To: T10 Technical Committee
 From: Rob Elliott, HP (elliott@hp.com)
 Date: 4 April 2006
 Subject: 06-164r1 SAS-2 Require expanders transmit three AIPs

Overview

Figure 1 — Extended primitive sequence

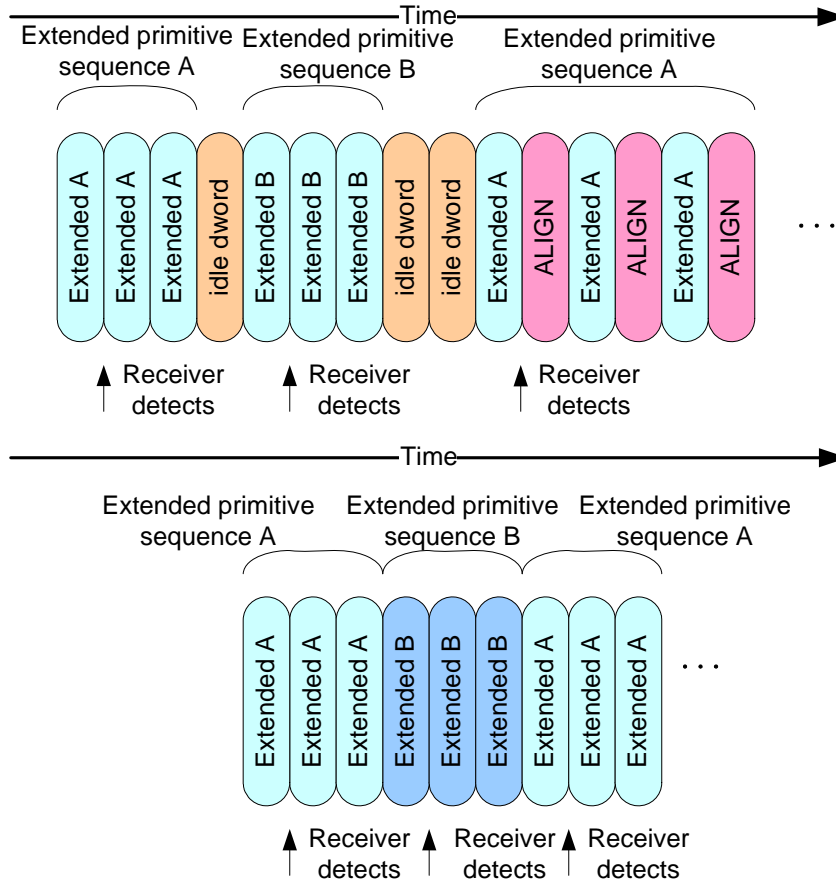
[7.2.4.x Extended primitive sequence](#)

[Primitives that form extended primitive sequences \(e.g., AIP\) shall be transmitted three times consecutively. ALIGNs and NOTIFYs may be sent inside primitive sequences as described in .](#)

[A receiver shall detect an extended primitive sequence after the primitive is received one time. After receiving an extended primitive sequence, a receiver shall not detect a second instance of the same extended primitive sequence until it has received one dword that is not any of the following:](#)

- a) [the original primitive; or](#)
- b) [an ALIGN or NOTIFY.](#)

Figure 1 shows examples of extended primitive sequences.
